Subject: Notification of Class I Permit Modification for the Los Alamos National Laboratory (LANL) Hazardous Waste Facility Permit to Add Structures to a Container Storage Unit, EPA ID # NM0890010515

Class 1 Permit Modification Notification Addition of Structures within Technical Area 54, Area G, Pad 11, Dome 375 Los Alamos National Laboratory Hazardous Waste Facility Permit July 2012

**Class 1 Permit Modification Notification Addition of Structures within
Technical Area 54, Area G, Pad 11, Dome 375**

LAUR-12-22808

Figure 36: TA-54, Area G, Pad 11

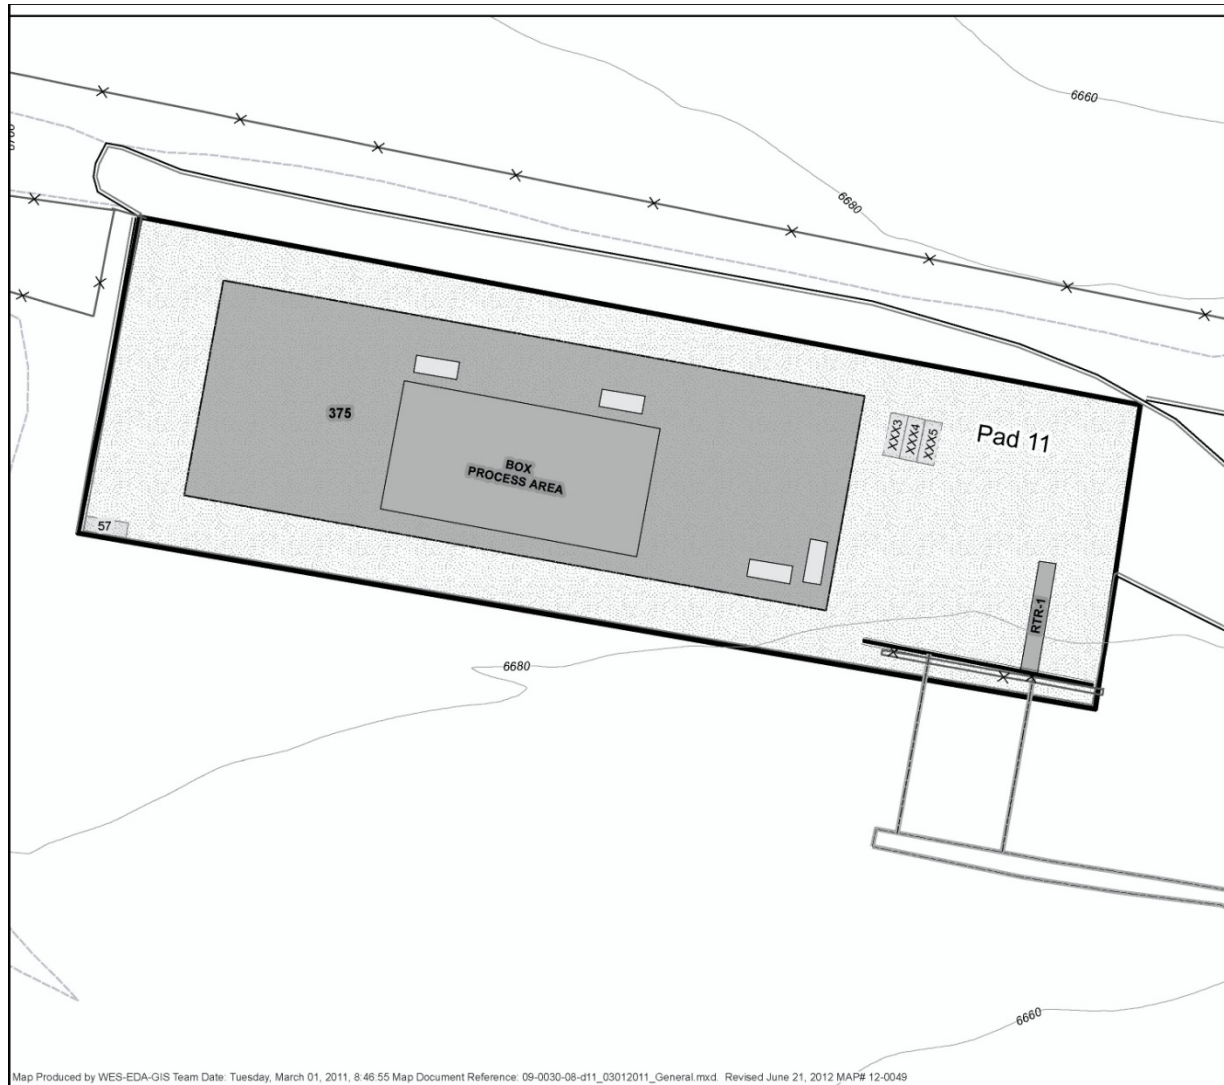
The modification adds structures to the container storage unit at Technical Area (TA) 54 Area G, Pad 11. Structures that will not be used to manage hazardous waste have been added within Dome 375 located at TA-54, Area G, Pad 11.

Descriptions of the structures have been added to Section A.4.2.9 in Attachment A, *TA – Unit Descriptions*; and Section 2.0 in Attachment G.12, *Technical Area 54, Area G, Pad 11 Outdoor Container Storage Unit Closure Plan*. Revised figures are Figure 36 in Attachment N, *Figures*; and Figure G.12-1 in Attachment G.12, *Technical Area 54, Area G, Pad 11, Outdoor Container Storage Unit Closure Plan*.

This asphalt pad is approximately 4 inches thick, measures approximately 478 ft long by 137 ft wide, and is sloped approximately 1 to 2% to the southeast. Storage dome 375 is located on the western portion of pad 11 and is used for storage of hazardous, mixed low level, and mixed transuranic waste. It measures approximately 300 ft long by 100 ft wide (see Figure 36 in Attachment N (Figures)). The building is an aluminum A-frame truss design that is anchored to a concrete ring wall. The dome is of modular construction utilizing a membrane or fabric covering. It is equipped with 14 personnel doors and two roll-up doors, one each at the east and west ends of the building. Ramped entrances allow for safe movement of container handling equipment and vehicle access. Dome 375 contains a modular panel containment structure (approximately 120 feet long x 60 feet wide) used for size reduction, decontamination, segregation, waste assay, reclassification activities, and repackaging of transuranic waste prior to shipment offsite. Dome 375 also contains four structures that serve as an office area, a control area, and rooms for donning and doffing anti-contamination clothing. These structures are support structures and will not be used to store hazardous waste. The Real-Time Radiography (RTR) system #1 is designed to provide X-ray examination of the contents of a waste drum. The unit, RTR1, has been located on Pad 11 in support of the transuranic waste characterization operations.

Figure G.12-1: Technical Area 54, Area G, Pad 11 Outdoor Container Storage Unit Grid Sampling and Additional Sampling Locations

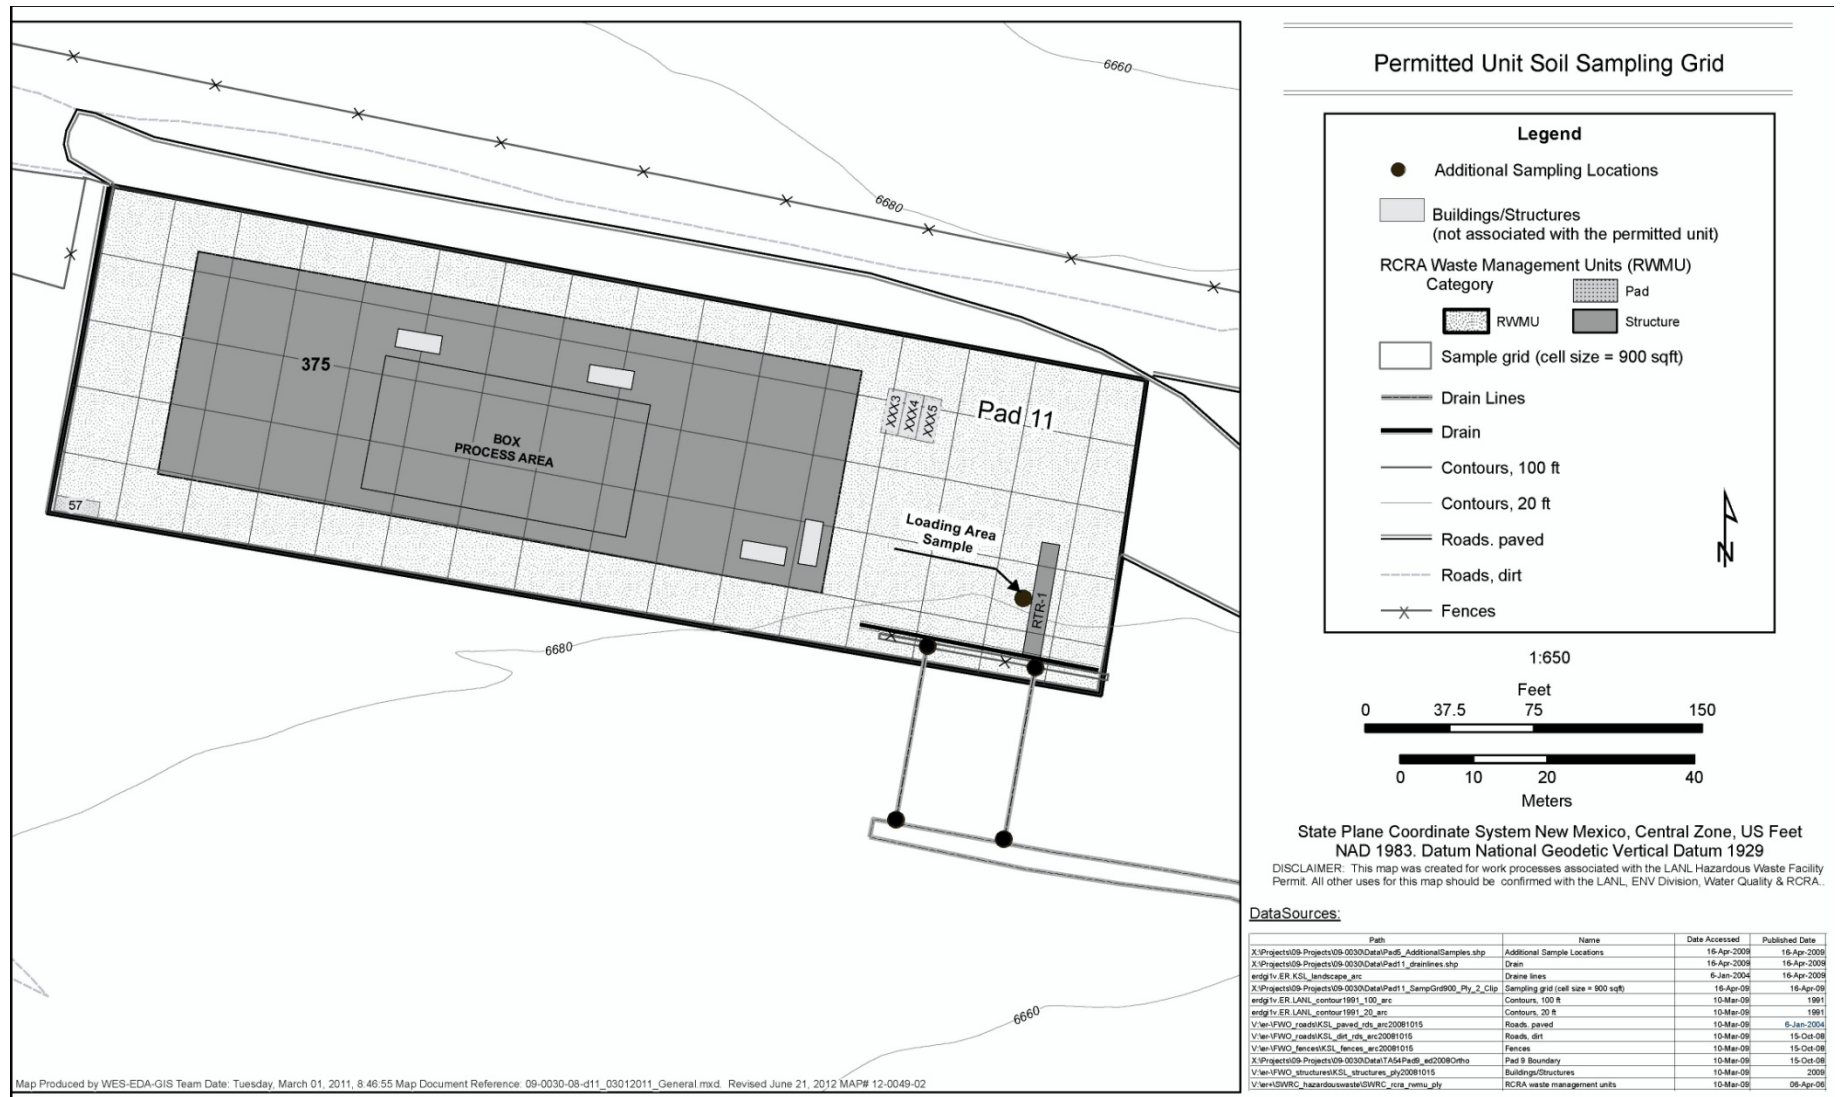
The structures will not be used for waste management activities; therefore, changes have not been made to the proposed sampling locations or the structural assessment sections of the closure plan or to the list of active units in Attachment J, *Hazardous Waste Management Units*.

two double-panel rolling doors, one at the east end of the dome and the other on the west end. It also has 14 personnel doors located approximately every 31 to 57 feet along the dome's length. These doors allow for adequate access both by vehicles and by personnel. The interior perimeter of the dome is surrounded by a concrete ring wall, which helps prevent run-on into and runoff from the dome. Asphalt ramps located at the vehicle entrances allow vehicles and container handling equipment to pass safely over the curb. Dome 375 contains a modular panel containment structure (approximately 120 feet long x 60 feet wide) used for size reduction, decontamination, segregation, waste assay, reclassification activities, and repackaging of transuranic waste prior to shipment offsite. Dome 375 also contains four structures that serve as an office area, a control area, and rooms for donning and doffing anti-contamination clothing. These structures are support structures and will not be used to store hazardous waste.
